CITY OF SOMERVILLE, MASSACHUSETTS MAYOR'S OFFICE OF STRATEGIC PLANNING & COMMUNITY DEVELOPMENT JOSEPH A. CURTATONE MAYOR

GEORGE PROAKIS, DIRECTOR OF PLANNING LORI MASSA, SENIOR PLANNER DAN BARTMAN, SENIOR PLANNER AMIE HAYES, PLANNER MELISSA WOODS, PLANNER DAWN PEREIRA, ADMINISTRATIVE ASSISTANT Case #: ZBA 2013-74 Date: November 14, 2013 Recommendation: Conditional Approval

PLANNING STAFF REPORT

Site: 739 Somerville Avenue

739 Somerville Ave: Front of building and streetscape (above), Other mansards on the block (below)

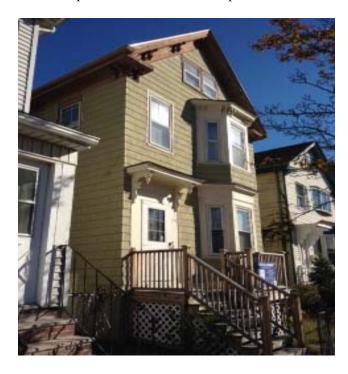
5. Impacts of Proposal: The proposal will change the building type from a $2\frac{1}{2}$ story gable structure to a 3 story mansard structure. This is generally discouraged; however, the current proposal will not negatively impact the streetscape. The mansard is designed in a very traditional form that can be found throughout the City. The shape of the mansard is appropriate and there will be brackets along the fascia board. The dormers are small and a single window fills the main wall. Also, mansard roofs are not unusual for the block as there are two buildings within close proximity that have mansard roofs. A large shed dormer that was originally approved for the building to get a code compliant staircase to the third floor would also greatly alter the $2\frac{1}{2}$ story structure and arguably be more detrimental.

The back of the roof is flat and does not carry the mansard shape around the back. The back can only be seen from the abutters to the rear and their view of the house will appear like a gambrel.

The mansard is designed in a very traditional form that can be found throughout the City. The shape of the mansard is appropriate and there will be brackets along the fascia board. The dormers are small and a single window fills the main wall. Also, mansard roofs are not unusual for the block as there are two buildings within close proximity that have mansard roofs.
